**PLANNED UNIT DEVELOPMENT &
SUBDIVISION STAFF REPORT****Date: June 5, 2003**

DEVELOPMENT NAME West Hill LLC (Tom Carwie, Agent)

SUBDIVISION NAME West Hill Subdivision

SITE PLAN

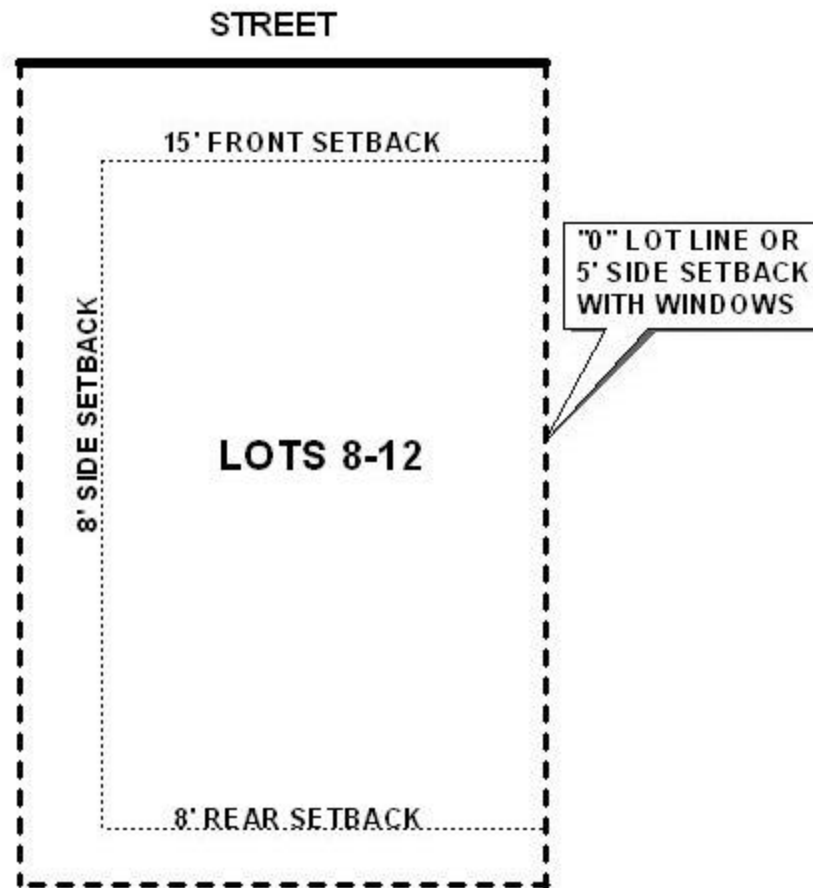
As illustrated on the plat, there is a large 60-inch diameter live oak located on the site; this tree should be preserved, and any work within the canopy of the tree should be coordinated with and approved by Urban Forestry. It should also be noted that this was a condition of the previous approvals.

While Lots 1-5 contain less than 7200 square feet in area, the overall density of the site, exclusive of the street and detention area, complies with R-1 density requirements.

Planned Unit Development: Based upon the preceding, it is recommended that this application be approved for **45%** site coverage, with reduced lot widths, lot sizes, and building setbacks subject to the following conditions: 1) maximum site coverage of 45% per lot; 2) reduced setbacks as shown on the plat submitted; 2) preservation of the 60-inch live oak on Lot 1, and any work within the canopy of the tree to be coordinated with and approved by Urban Forestry; 3) dedication and construction of the street to City standards; and 4) full compliance with all municipal codes and ordinances.

Subdivision: With modifications, the plat will meet the minimum requirements of the Subdivision Regulations and is recommended for Tentative Approval subject to the following conditions: 1) maximum site coverage of 45% per lot; 2) reduced setbacks as shown on the plat submitted; 2) placement of a note on the final plat stating that the 60-inch live oak on Lot 1 is preserved, and any work within the canopy of the tree must be coordinated with and approved by Urban Forestry; 3) dedication and construction of the street to City standards; and 4) full compliance with all municipal codes and ordinances.
